# Kirby Morgan Dive Systems, Inc.®

**Bulletin #8 of 2022. June 20, 2022**

## **CHANGE TO PRODUCT BULLETIN**

**P/N 540-095 Packing Washer Now 316L Stainless Steel**

*Current P/N 540-095 Packing Washer, left and center left, and previous, center right and right.*

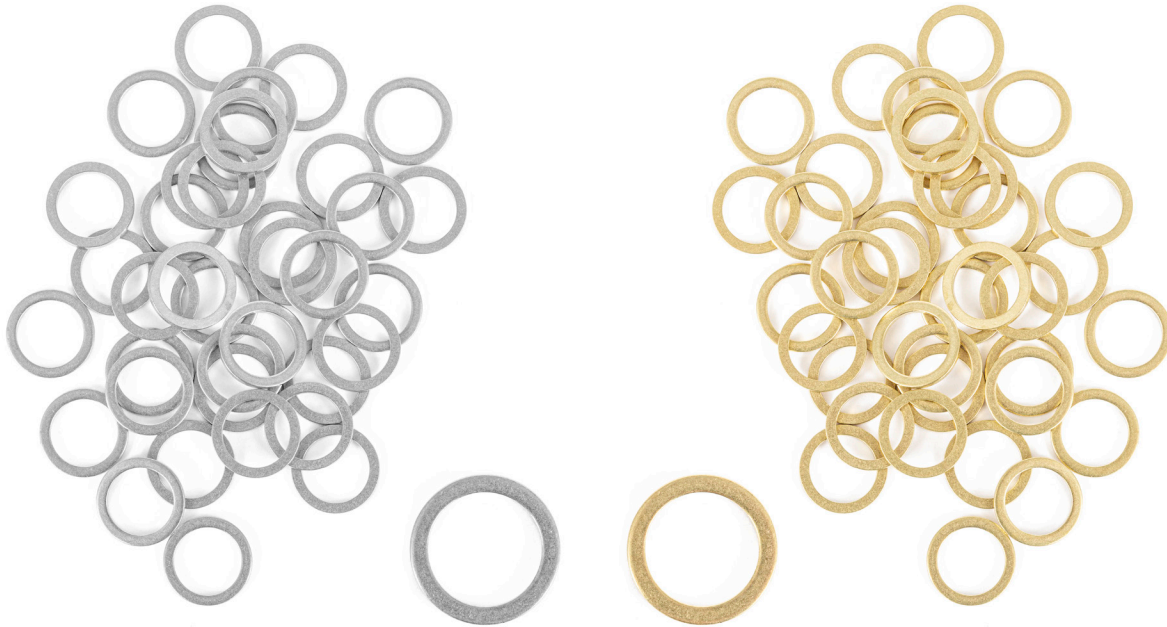
Switching from brass to stainless steel material will reduce the difference in the electrode potential between the Packing Washer and the Valve Stem adding to the longevity of the components.

Any old stock of the Packing Washer can be used without issue.

No change in part numbers.
